SITE ASSESSMENT REPORT (NOT A CONSTRUCTION PERMIT)

SUBDIVISION: PARCEL 1600, SITE ONE LOT NO: _____

SUBDIVISION: PARCEL 1600, SITE TWO LOT NO: _____

SITE SURVEY DRAWING FOR SOIL ANALYSIS LOCATIONS

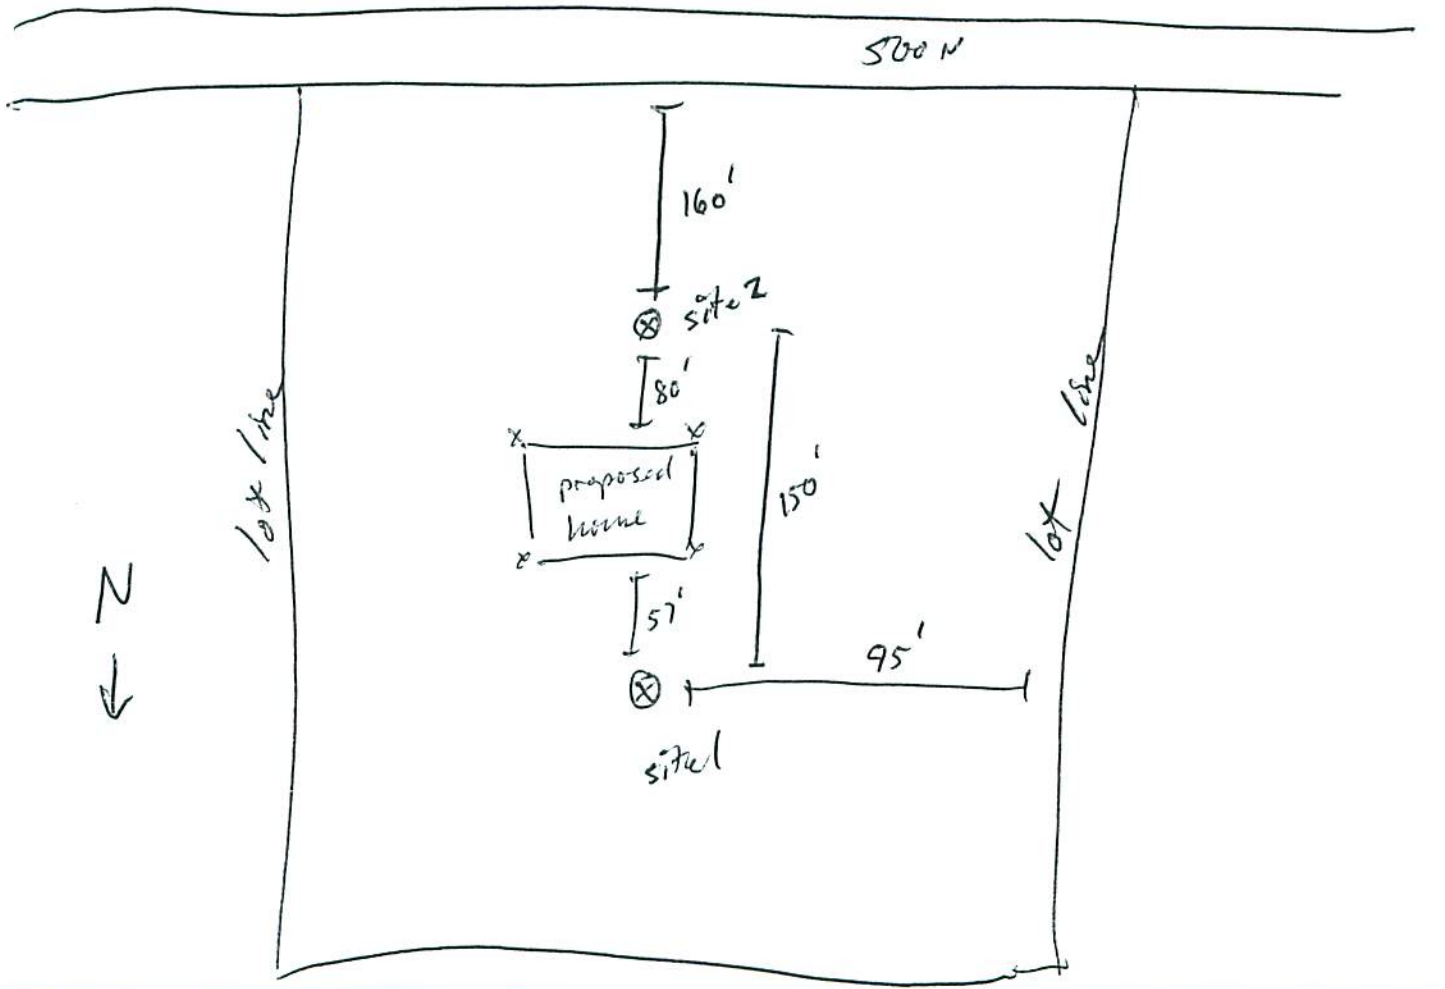
5. The system area must be located at soil boring one, located 160 feet North of 500 N. and 95 feet East of West lot line.
6. System area must be protected from excavation, grading, filling, compaction, or any other construction related activities that could render the site unsuitable if disturbed. This department recommends that a barrier be placed around the system area to protect it.

6. The system area must be located at soil boring two, located 310 feet North of 500 N. and 95 feet East of West lot line.
7. System area must be protected from excavation, grading, filling, compaction, or any other construction related activities that could render the site unsuitable if disturbed. This department recommends that a barrier be placed around the system area to protect it.
